**Meeting of the Central Valley Flood Protection Board  
July 27, 2012  
Staff Report – Encroachment Permit  
Sacramento Area Flood Control Agency (SAFCA)  
Unionhouse Creek Improvements, Sacramento County**

Consider approval of Permit No. 18777

The applicant proposes to widen the existing concrete-lined bottom of Unionhouse Creek by 8-feet from Franklin Boulevard to Center Parkway; and to concrete line the side slopes of Unionhouse Creek from Center Parkway to Bruceville Road; and relocate an existing City of Sacramento sump pump (Sump No. 201).

SAFCA Permit No. 18777

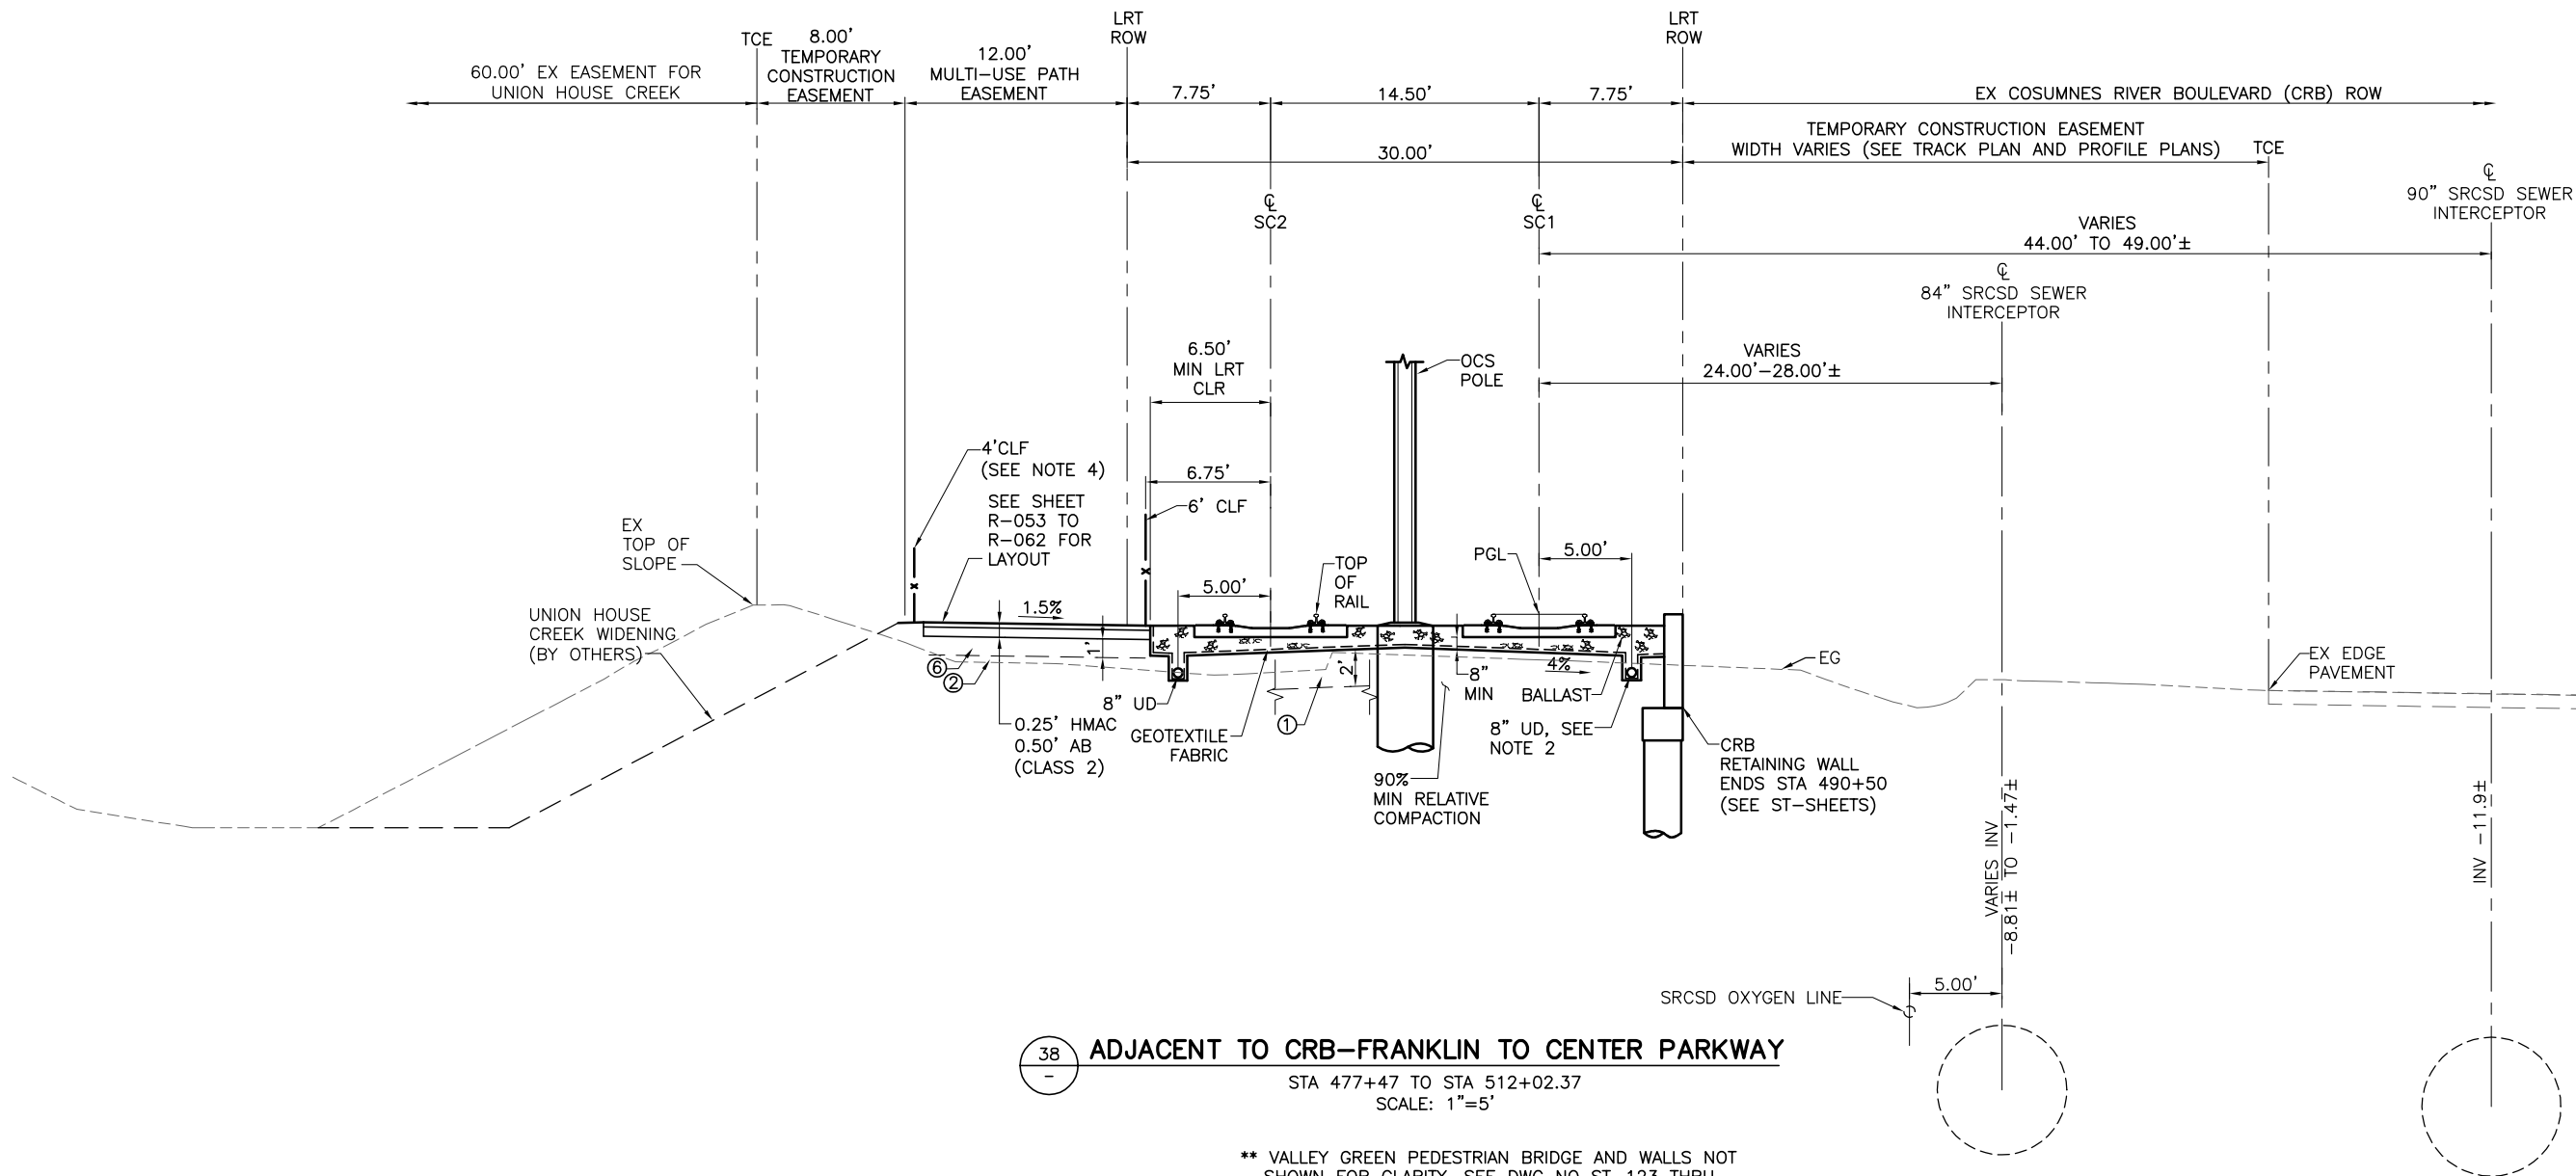
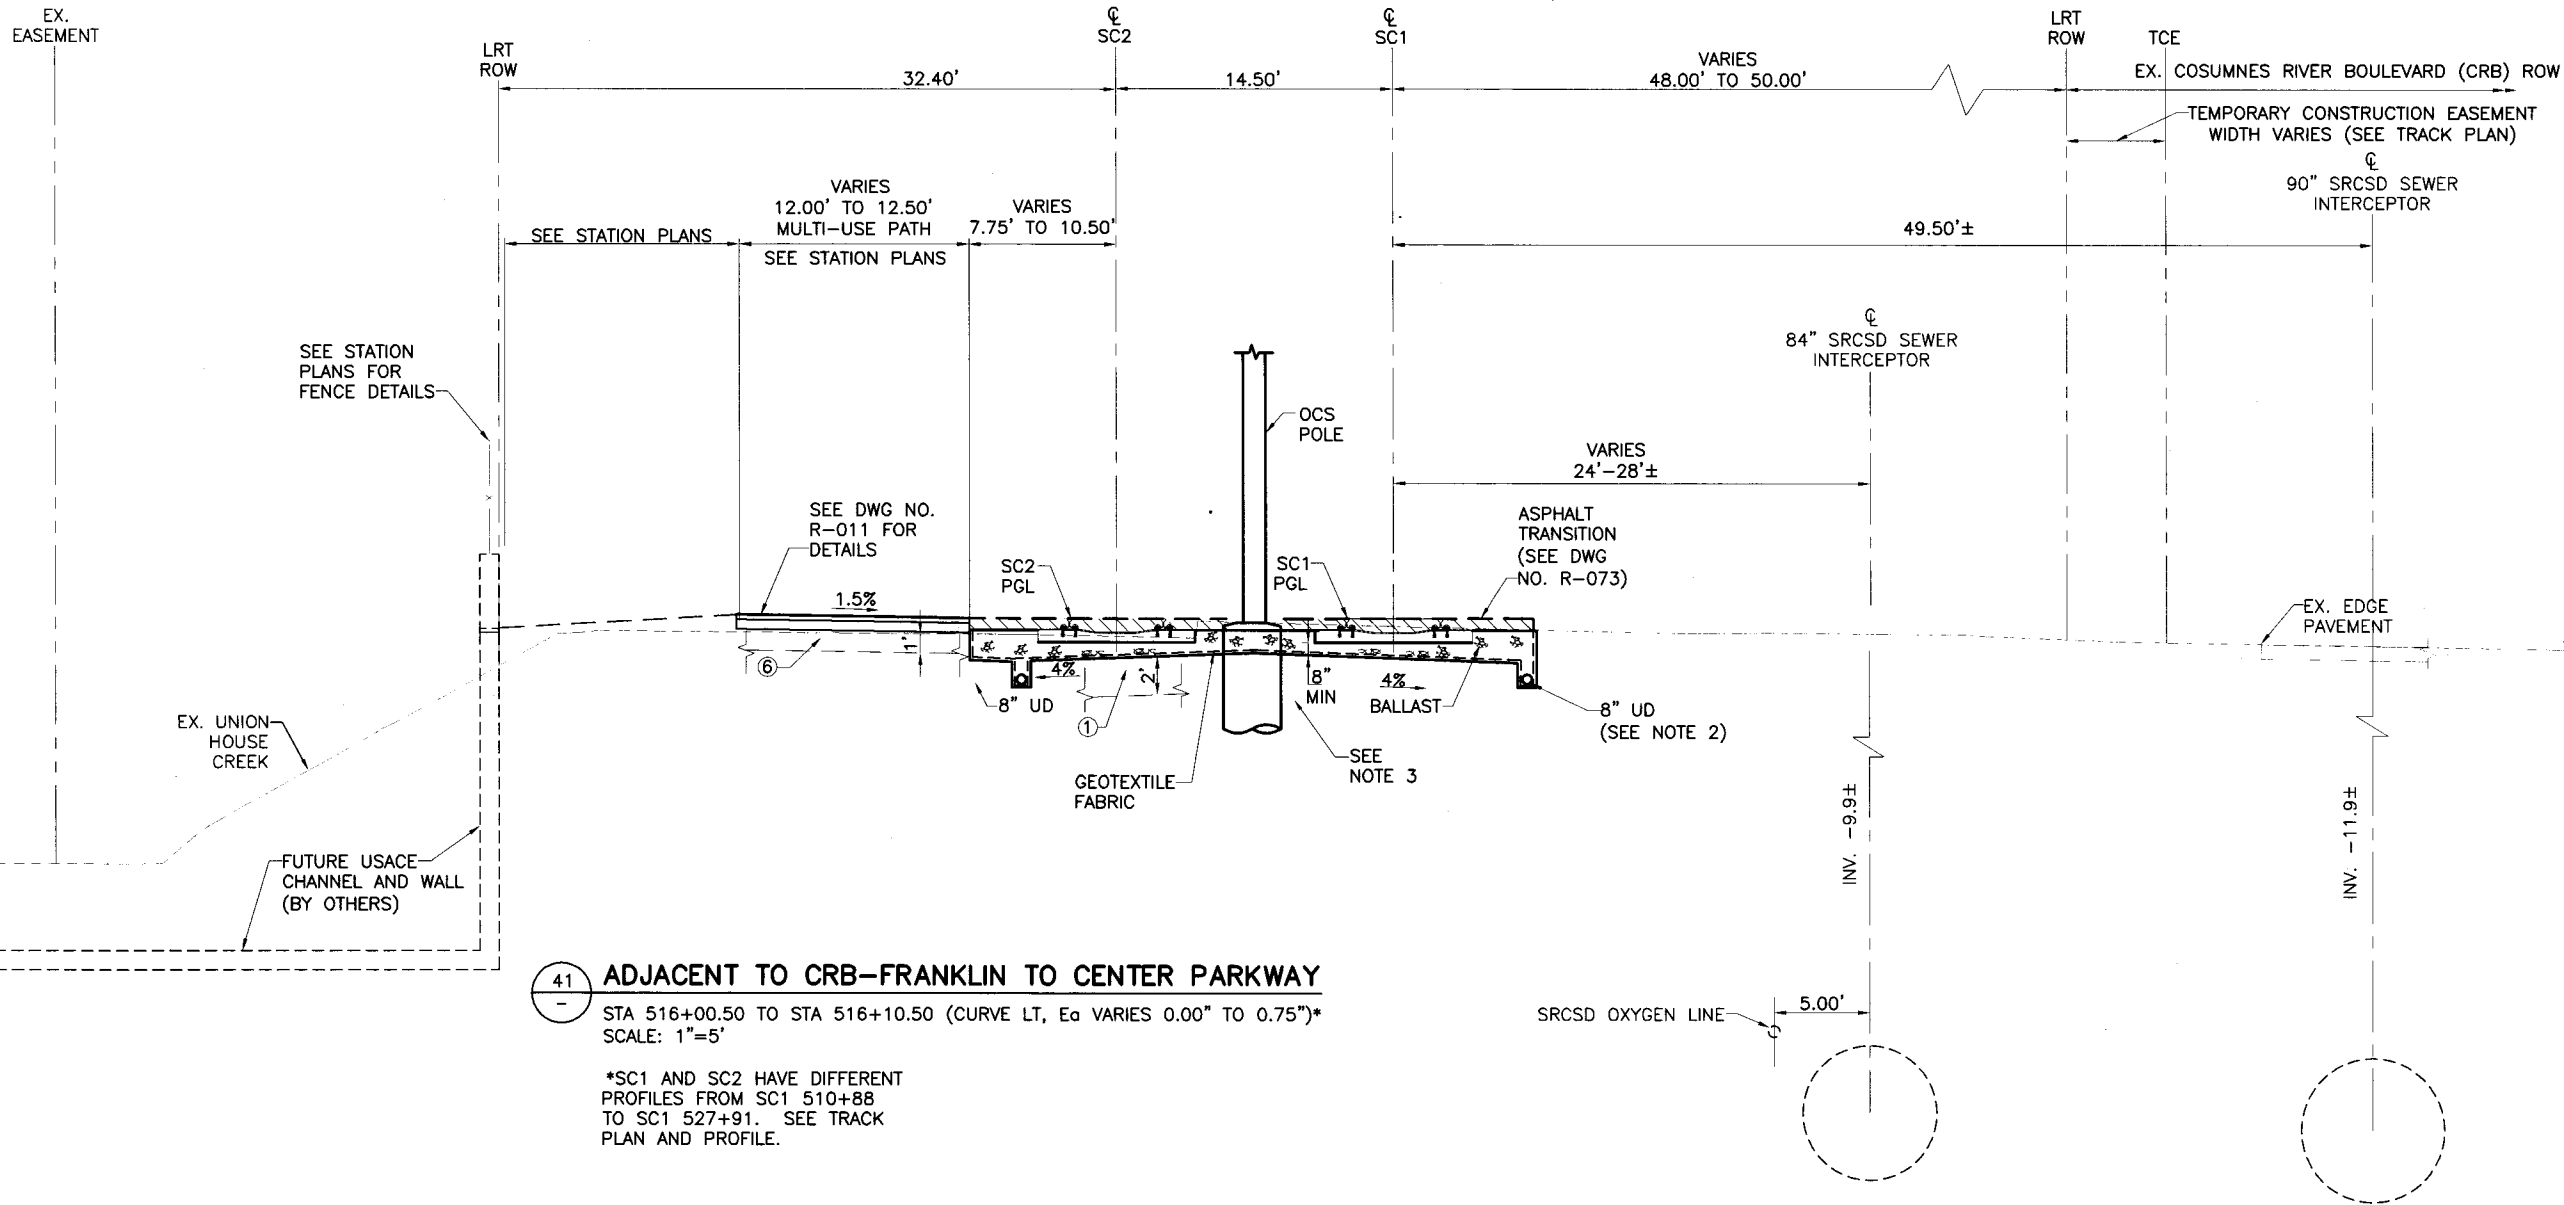
Sacramento Regional Transit (RT) applied for and received a Central Valley Flood Protection Board (CVFPB) permit on June 19, 2012, to extend their South Corridor Light Rail Line along Unionhouse Creek in Sacramento, California (Permit No. 18166-2). Within that CVFPB permit application package, flood control improvements to Unionhouse Creek were shown as a concrete rectangular shaped channel as part of a future US Army Corps of Engineers (USACE) flood control project. However, the Sacramento Area Flood Control Agency (SAFCA) and the City of Sacramento could not afford the estimated high cost (\$40 million) for that USACE channel improvement at this time, so they proposed in this subsequent CVFPB permit application package to widen 1 mile of Unionhouse Creek instead of installing the rectangular shaped channel, and then concrete line an additional 0.5 miles of Unionhouse Creek upstream of this proposed widening, at a cost of about \$2 million. The USACE rectangular shaped channel design would have lowered the existing Unionhouse Creek flow line by 2 feet, however SAFCA's proposed widened portion of Unionhouse Creek maintains the

existing flow line elevation. Attachment B shows the difference in proposed flood control improvements for Unionhouse Creek next to the proposed RT Light Rail Line from RT's permit application No. 18166-2 and SAFCA's permit application No. 18777.
